Subject: Request to Withdraw and Resubmit a Class 1 Permit Modification Request to the Los Alamos National Laboratory (LANL) Hazardous Waste Facility Permit, EPA ID No. NM0890010515

**Class 1 Permit Modification Request Addition of a Structure within Technical Area
55, Outdoor Storage Pad**

**Los Alamos National Laboratory Hazardous Waste Facility Permit
August 2012**

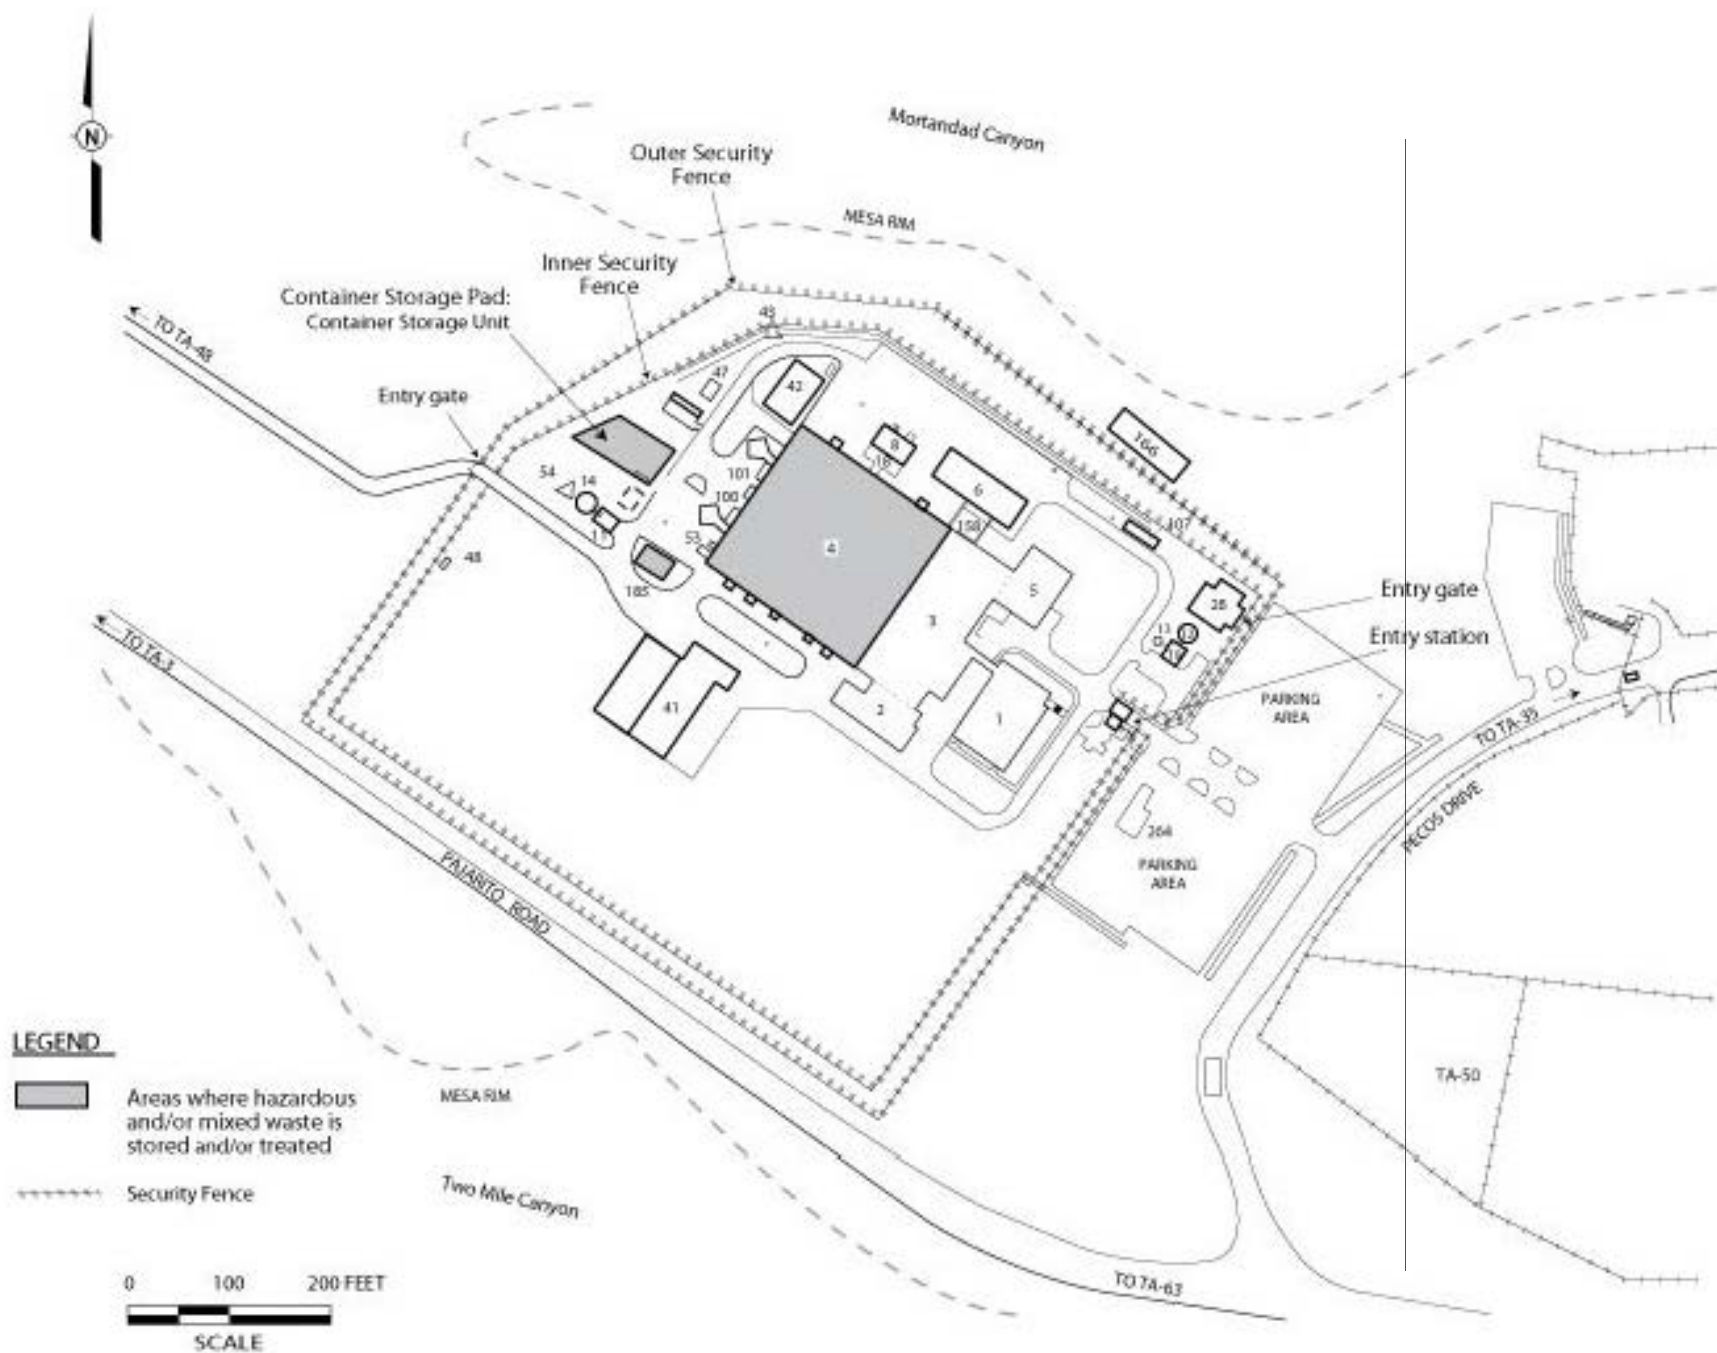
Descriptions of the structures have been added to Section A.5.6 of Attachment A, *TA – Unit Descriptions*; Sections 2.0 and 5.2.2 of Attachment G.26, *Technical Area 55 Outdoor Storage Pad Closure Plan*; and Table J-1 of Attachment J, *Hazardous Waste Management Units*. Revised figures are Figures 10, 39, and 45 of Attachment N, *Figures*; and Figure G.26-1 of Attachment G.26, *Technical Area 55 Outdoor Storage Pad Closure Plan*.

Figure 45
Technical Area (TA)-55, Building 4, Outdoor Container Storage Pad

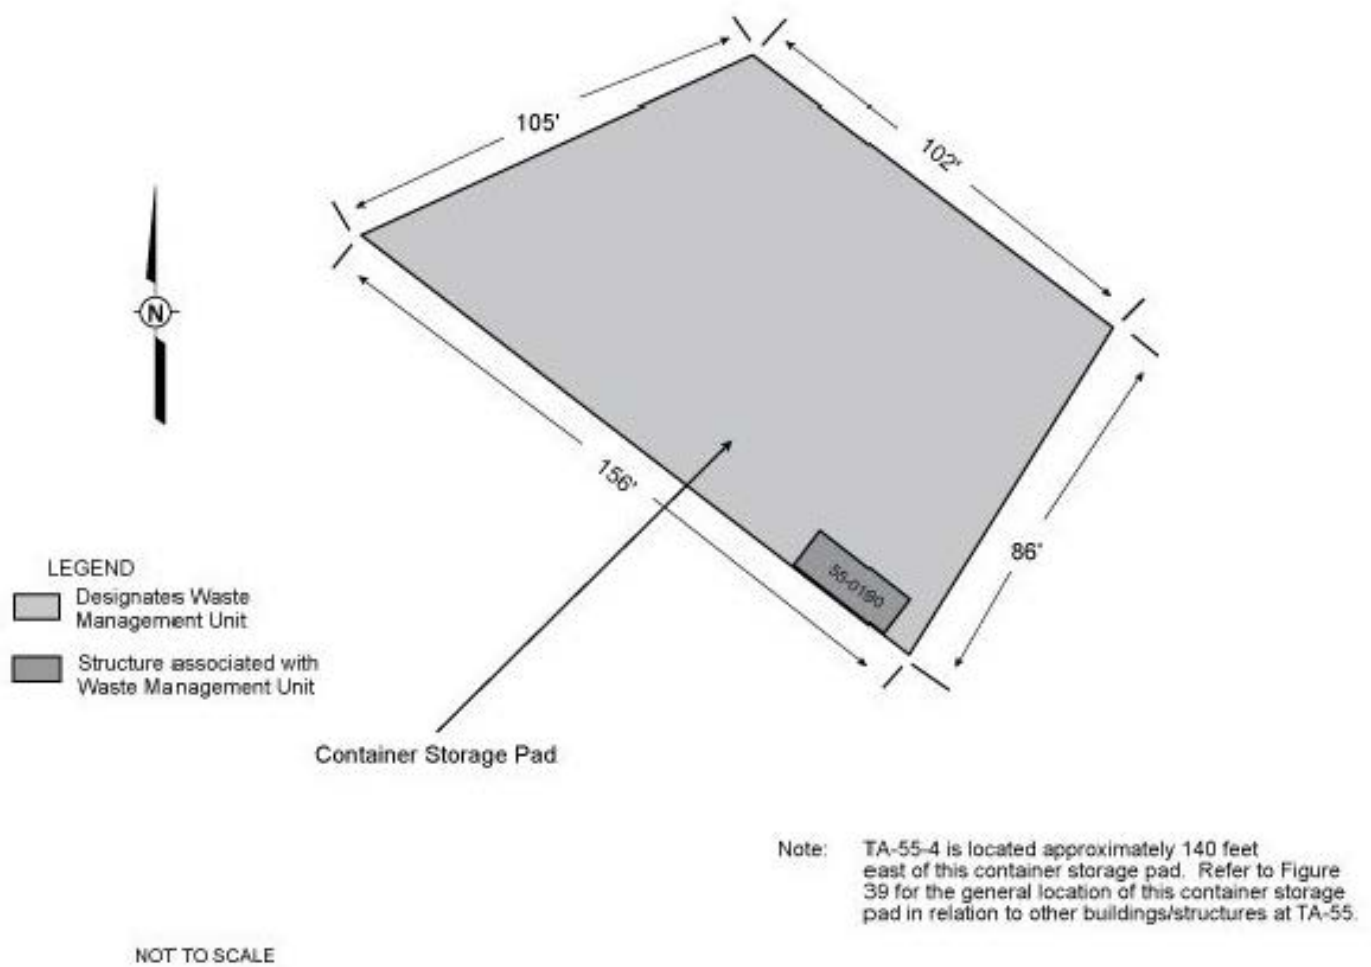
Waste containment storage building TA-55-PF-190 is located on the south-eastern portion of the Container Storage Pad and is used for storage of hazardous waste. It measures approximately 22 feet long and 8 feet 4 inches wide (see Figure 45 in Attachment N (*Figures*)). The building is a manufactured steel building that is designed for hazardous waste storage.
